Subject: Comments on the proposed Anadromous Salmonid Protection Rules
(previously the Threatened or Impaired Watershed Rules) dated May 8, 2009,
as revised July 24, 2009, Title 14 of the California Code of Regulations

Subject: Review and Comments on the Board of Forestry proposed revisions to the
Anadromous Salmonid Protection Rules (previously the Threatened or Impaired
Watershed Rules) dated May 8, 2009, as revised July 24, 2009

Subject: Evaluation of Anadromous Salmon Protection Rules Relative to the
Water Quality Objective for Temperature

Figure 1: Graphic illustration of the stream temperature relaxation concept.

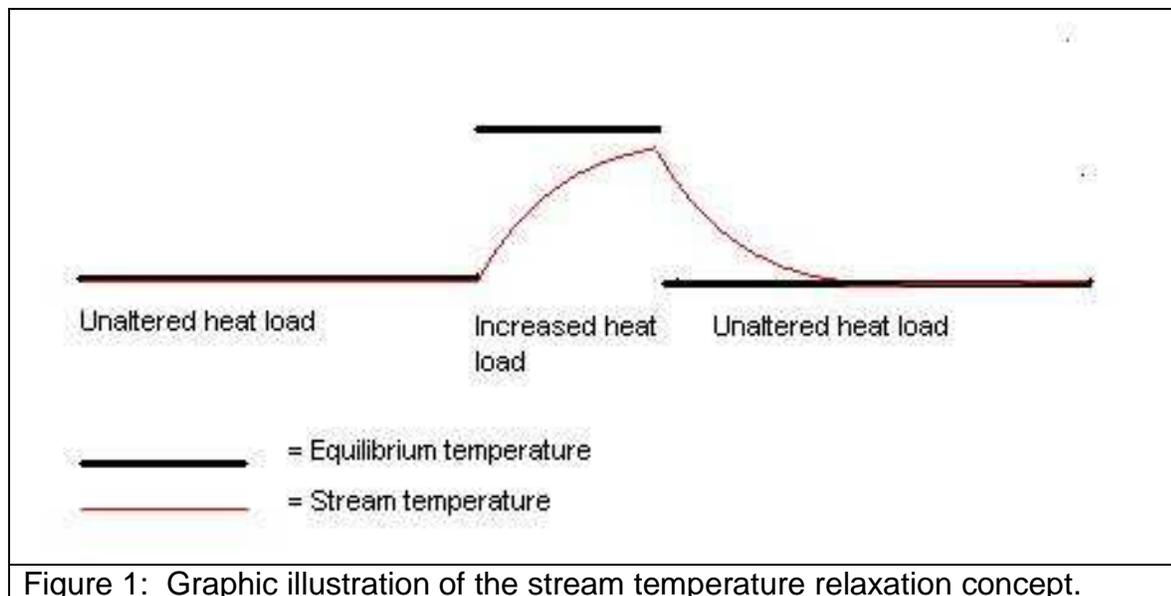
What the Literature Review does not do is recognize that the initial equilibrium temperature for such an example may not be “natural” and thus not meet the Basin Plan WQO for temperature in the first place. Given that equilibrium temperature is a fundamental concept in the stream temperature relaxation concept, it is notable that the *Literature Review* lacks any discussion that puts stream temperature dynamics in the context of equilibrium temperature. Equilibrium temperature is defined as the temperature that occurs when a balanced is achieved between heat sources and sinks (Bogan et al, 2003, Caldwell et al, 1991).

Figure 2: Illustration of difference in temperature profiles due to buffering.

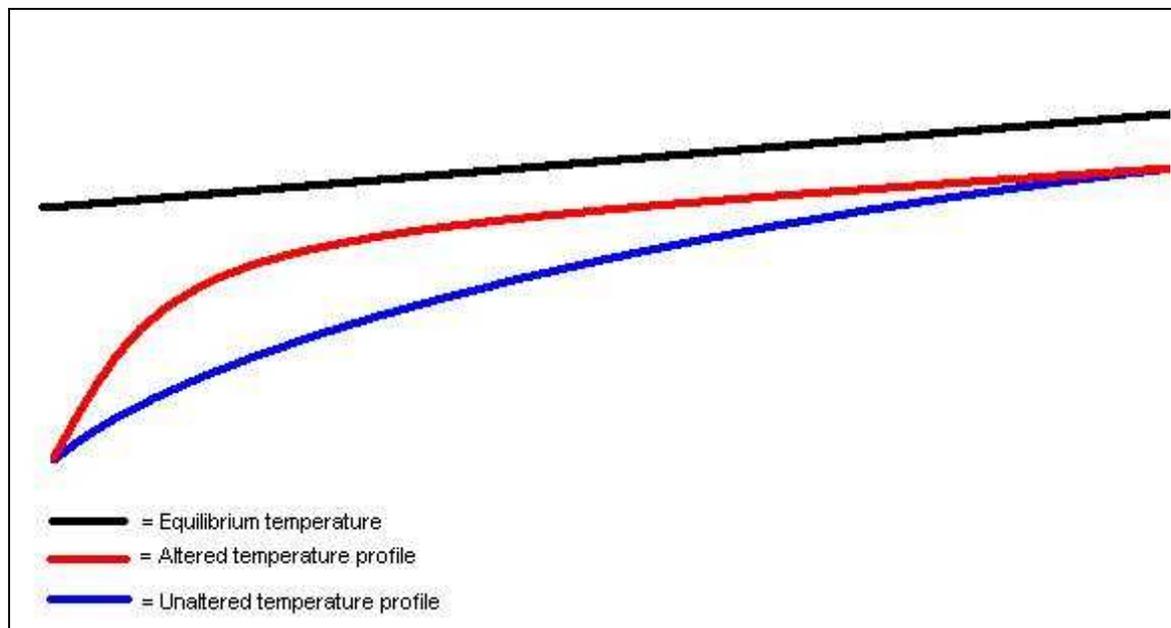
The second law of thermodynamics guarantees the temperature of a stream will trend towards the equilibrium temperature. Newton’s law of cooling tells us that the rate of temperature increase will be proportional to the difference between the waterbody’s temperature and the equilibrium temperature. This process continuously determines stream temperatures (Bogan et al, 2003). Effective management of stream temperatures for coldwater ecosystems is about limiting heat inputs to streams that are below equilibrium in order to minimize the rate of heating as the waterbody trends toward equilibrium (Figure 2).

In cases where water temperatures are relatively far from equilibrium temperature (such as downstream of springs, areas of high groundwater discharge, or melting snow) an increase in heat load may cause an increase in temperature that can't be mitigated by downstream conditions (Figure 3). In those situations the result is an acceleration of stream temperature in the downstream direction, rather than a localized increase quickly followed by an equal decrease. Management measures should be designed to prevent increased heat loads when the temperature of a waterbody is uniquely cold, regardless of stream classification.

Figure 3: Graphic illustration of temperature acceleration concept.

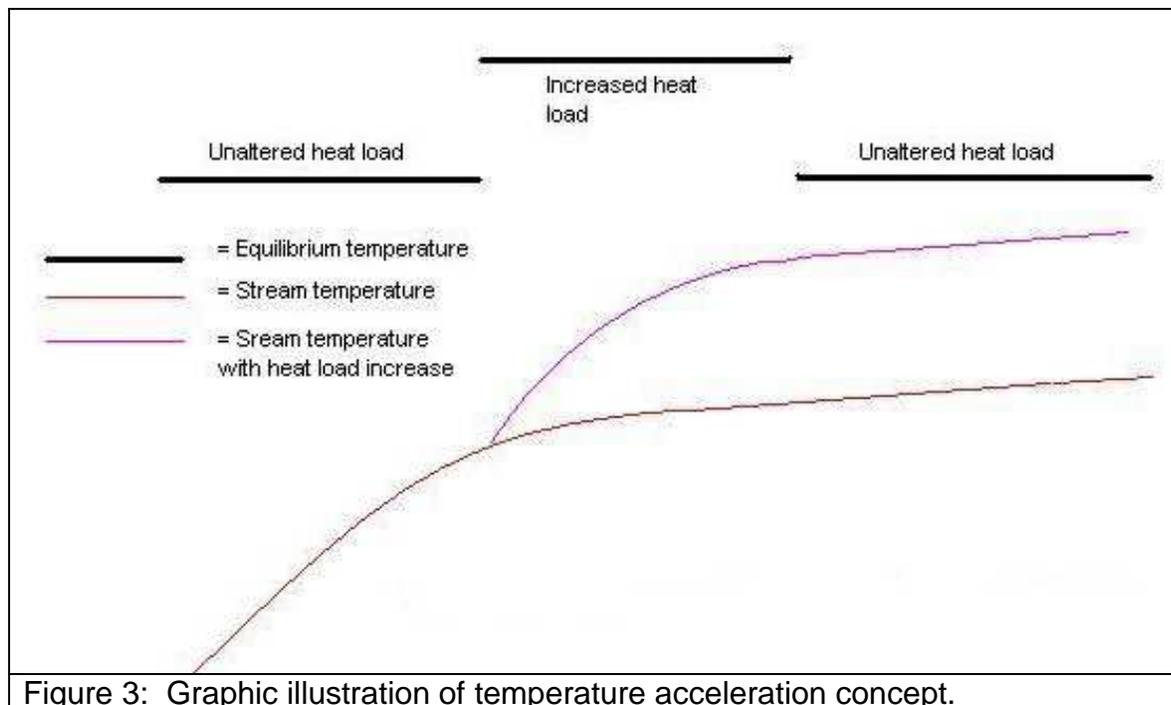
Regardless of the downstream cooling that may or may not occur, any temperature increase more than 5 °F constitutes a Basin Plan violation, and any increase in water temperature that adversely affects beneficial uses constitutes a Basin Plan violation. Given that stream temperatures are very sensitive to solar radiation inputs (Sound Watershed Consulting 2009), it is not unlikely that even modest increases in solar radiation can result in temperature increases of 5 °F or more.

Forest management and regulatory approaches that incorporate the concept of temperature relaxation should also consider the possibility of temperature acceleration as the response to the same management action, depending on the setting. The factor that determines whether or not a stream will “relax” is the equilibrium temperature. Streams that cool downstream of riparian harvest do so because the equilibrium temperature increases through the affected reach, then decreases in the downstream cooling reach. In these situations, the stream is already near equilibrium temperature. This is not always the situation, however.
